MANDATORY SERVICE BULLETIN No. E/02.152/94

For airplanes: PZL M18, M18A, M18AS DROMADER

Subject: Supplement to Bulletin No. E/02.142/91
extending the airplane service life
up to 6000 fl.hrs.

Subject: Extension of aircraft service life
up to 6000 flying hours.

SECTION NO. 2

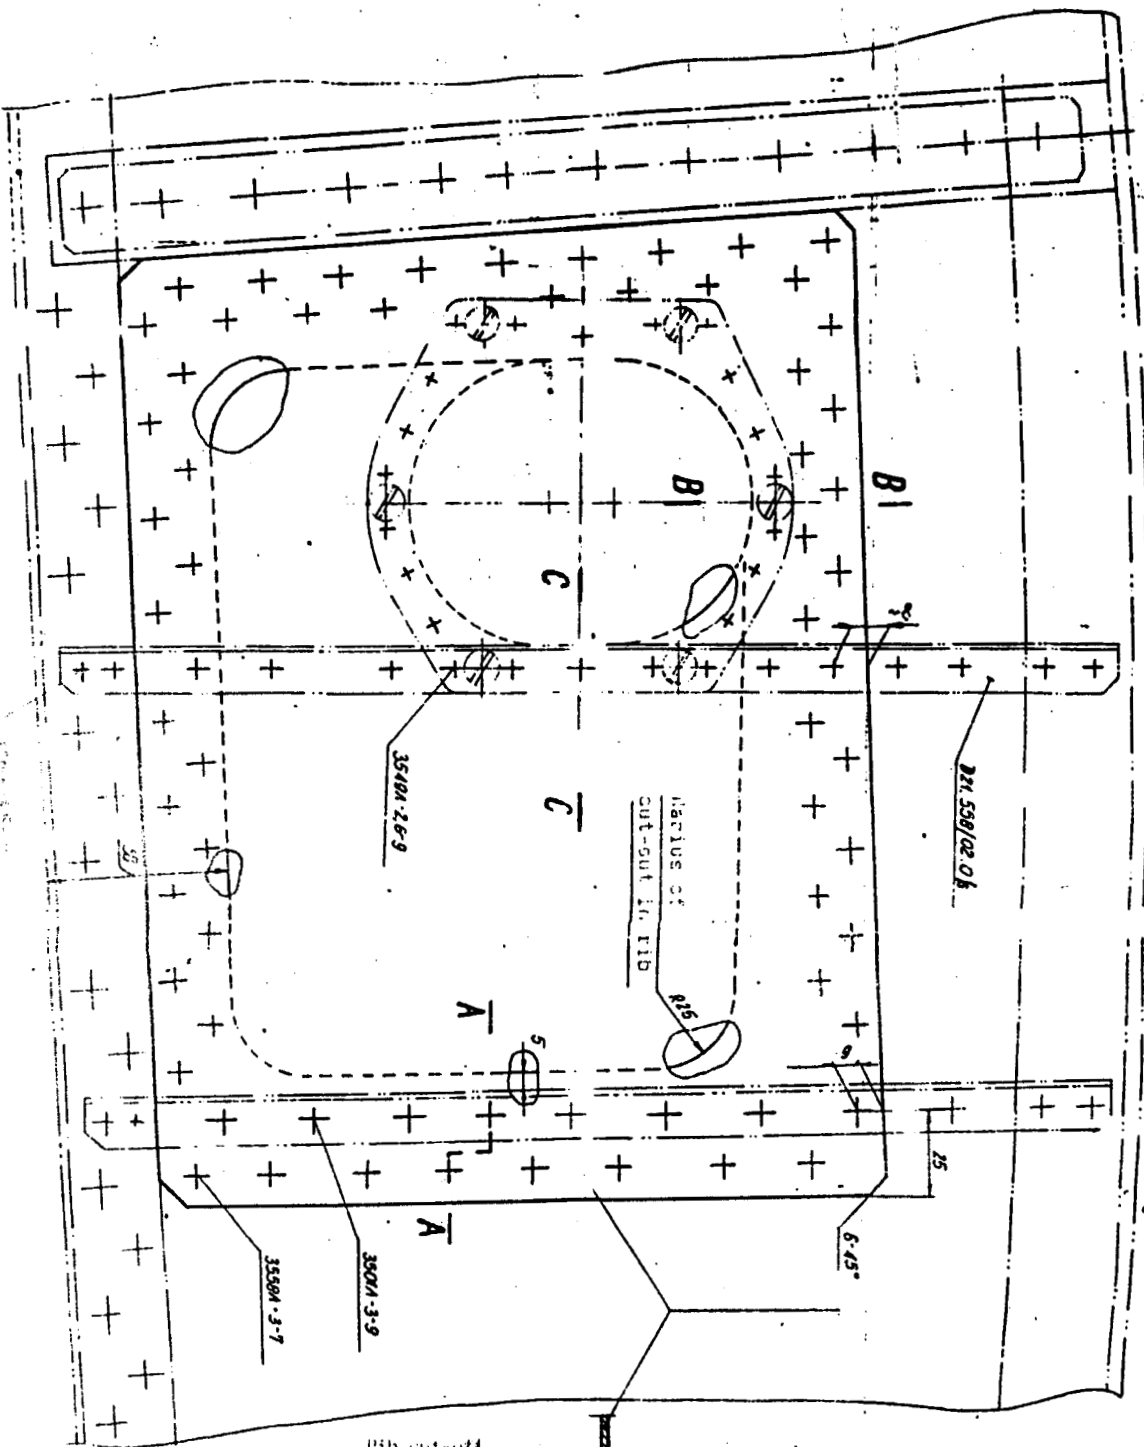
- 3.2.1. To facilitate work at drilling out rivets and boring holes up to dia. 7H8, repair peepholes shall be made in D21.550.00.0 L/P ribs per Sketch No.2. To this end, proceed as follows:
 - dismantle covers of the existing peep-holes
 - drill out rivets attaching D21.558/02.L/P angle bars and remove them
 - cut out the holes of radius R=25 mm in the ribs.

3.2.9. Rivet the repair cover plate, D21.558/02.0 L/P angle bar and make a peep-hole in the cover plate as shown in Sketch No.2.

SKETCH NO 1

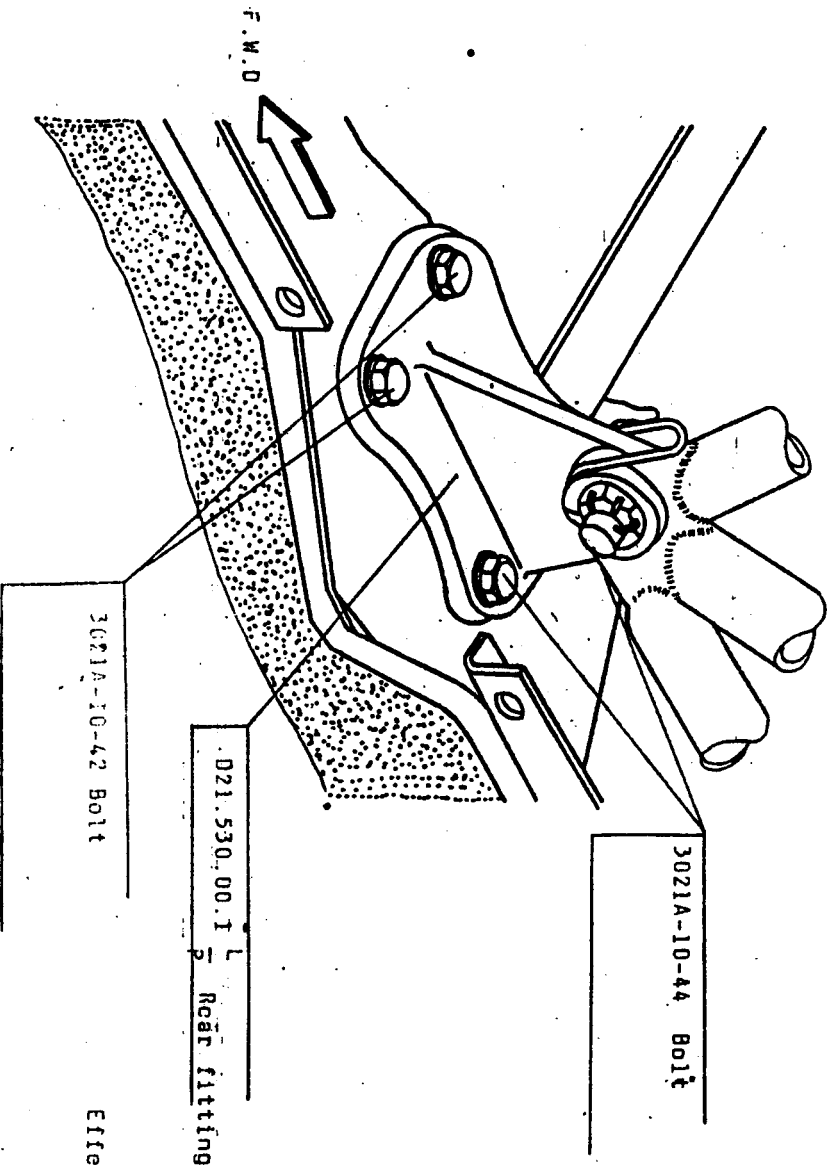
3.1. Replacement of D21.530.00.0 fittings for the D21.530.00.1 L/P on the aircraft S/N 12019-30 and down.

- 3.1.1. Remove outer wings.
- 3.1.2. Remove the centerwing after having disconnected the fuel lines, wires and control system.
- 3.1.3. Unscrew the bolts attaching D21.530.00.0 fittings to the centerwing at the rear spar.

- 3.1.4. Put the removed fittings into the D21.573.016988 fixture and basing on them set the fixture adjusters so as to trace the holes for the bolts attaching the fitting to the centerwing. After setting the fixture adjusters remove the old (reference) fitting and instead of it affix a new one for drilling out. Safeguard the new fitting against displacement using chucks.
- 3.1.5. Drill four holes of dia. 6 mm. bore then from dia. 6 to dia. 6.7 and then up to dia. 6.986 / $\frac{0.010}{0}$ and 10H8 / $\frac{0.010}{0}$ / using a reamer and finally make chamfers of 0.5/45° on either side.

- 3.1.6. Set shim washers and the bored fitting on the centerwing, securing it in place with two bolts inserted into the holes spaced diagonally, whereas the remaining two holes are to be drilled-out again with a reamer of ϕ 10H8. Insert 2 bolts into the enlarged holes, placing 3405A-0,5-10-18 washers under bolt heads. Next, put 3402A-1,5-10-18 washers over bolts and screw on nuts. Tighten bolts alternately so that uniform screwing can be obtained. Remove two bolts that held the fittings for boring two holes and drill out the remaining two holes with a reamer up to dia. 10H8. Place bolts, washers and nuts. Tighten nuts, screwing the bolts spaced diagonally.

SKETCH NO. 3

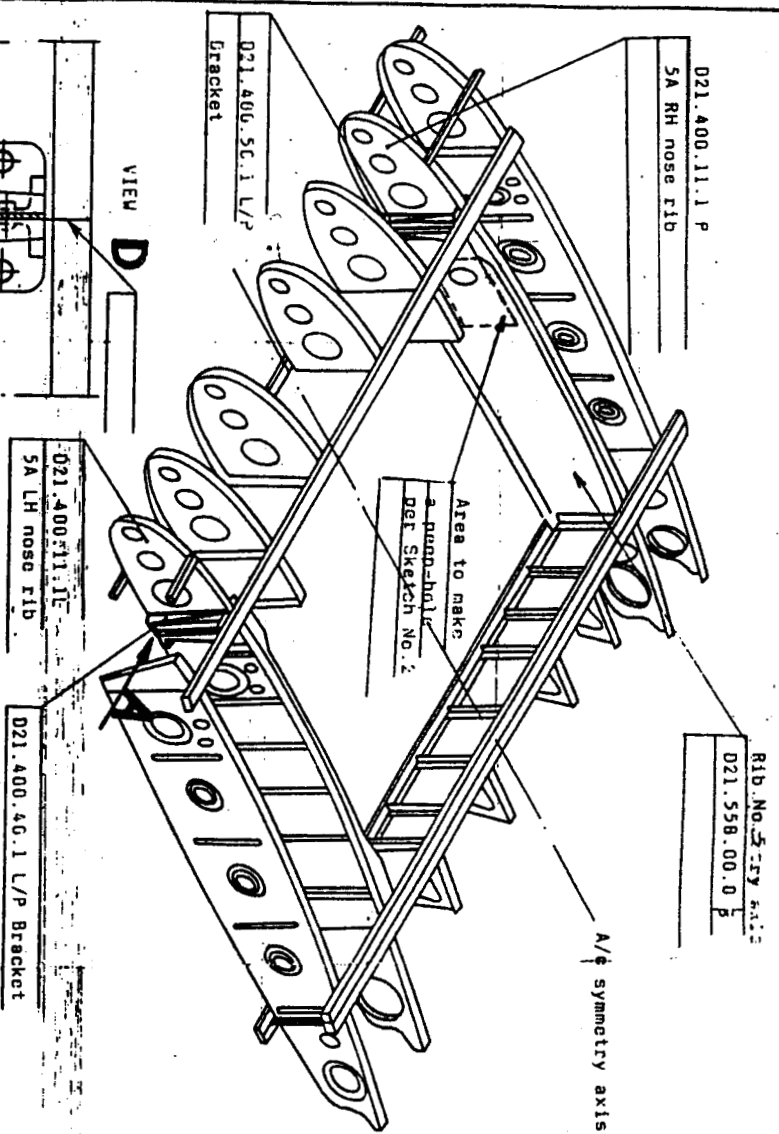
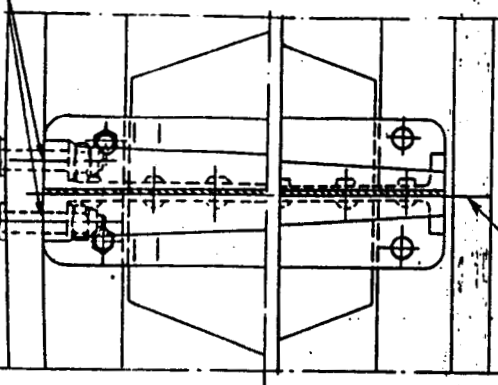
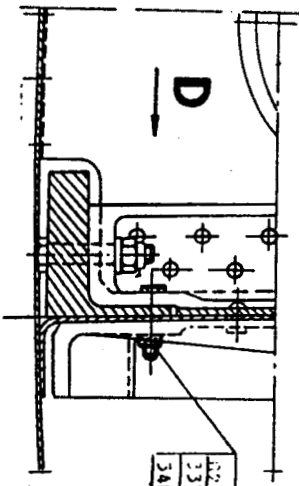
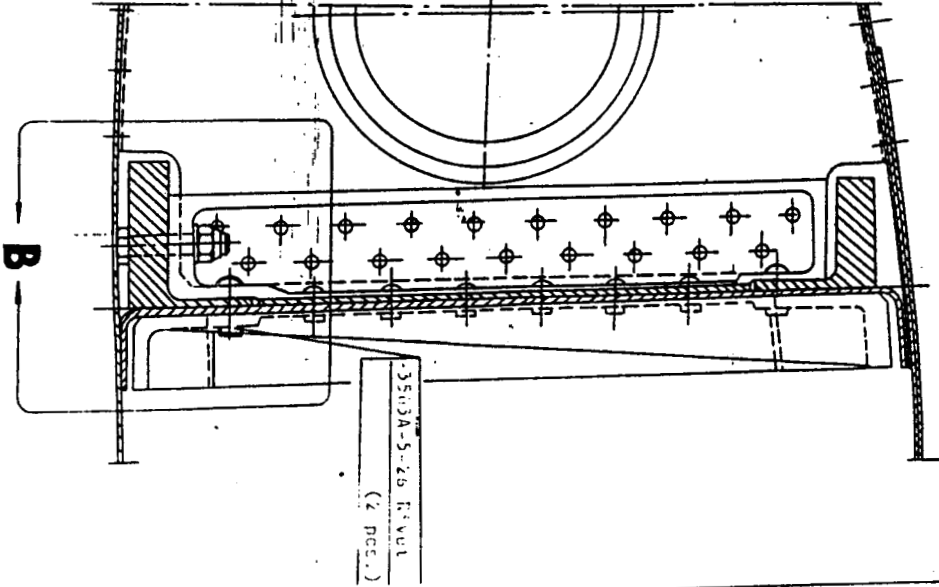
3.2.3. Remove 2 rivets (3503A-5-26) located symmetrically on either side of Rib 5A, view "D", both at the LM and RH aircraft side, in the area shown in Sketch No.3.

3.2.7. Connect the spar flange to the wall with D21.200.01.0R repair bolts as shown in Detail 8, Sketch No.3.

The bracket mount should rest against spar flange
